Re: Sydney Gateway EIS submission

The Cooks River Alliance (CRA) welcomes the opportunity to comment on the Environmental Impact Statement/ Preliminary Draft Major Development Project Plan (EIS) for the Sydney Gateway Road Project. The Cooks River Alliance (the Alliance) is a voluntary regional organisation of four Councils working towards a common mission to improve the health of the Cooks River Catchment. Please find our submission below.

Figure 1-1 Catchments and Waterways

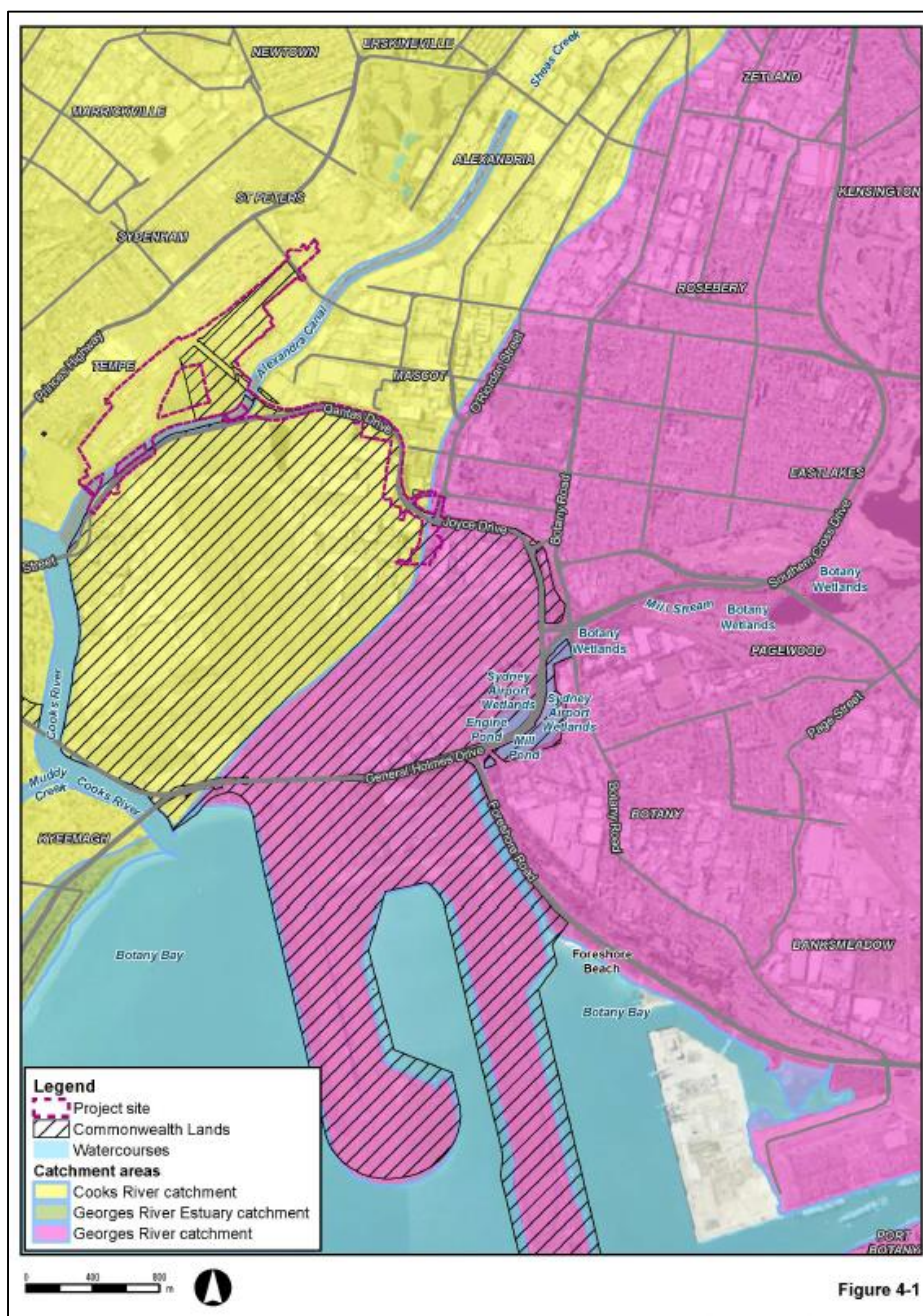
Catchment Boundary Mapping Errors

Catchment boundaries are incorrectly referenced within the flood and surface water assessment(s), with the area on the eastern extent of Figure 14.1 (as well as in Figure 3-5 and 4-1 Technical Working Paper 8) to the South east of Sydney Airport shown as within the Georges River Catchment. Although some catchment mapping may designate this area as Georges River Catchment, this delineation is inconsistent with the majority of the existing body of contemporary research and literature regarding the Cooks River and Georges River watersheds. This figure should be amended and updated in accordance with the current body of contemporary research or further explanation of the presented boundaries should be included within the EIS.

- Catchment boundaries used within the EIS should be amended and updated in accordance with the current body of contemporary research or further justified within the EIS.
- Assessment of gross pollutants loads against the BBWQIP target should be included. Further assessment of the proposed treatment trains should also be undertaken to ensure the Project meets (or at the very least maximises) operational pollutant load reductions for other BBWQIP targets.
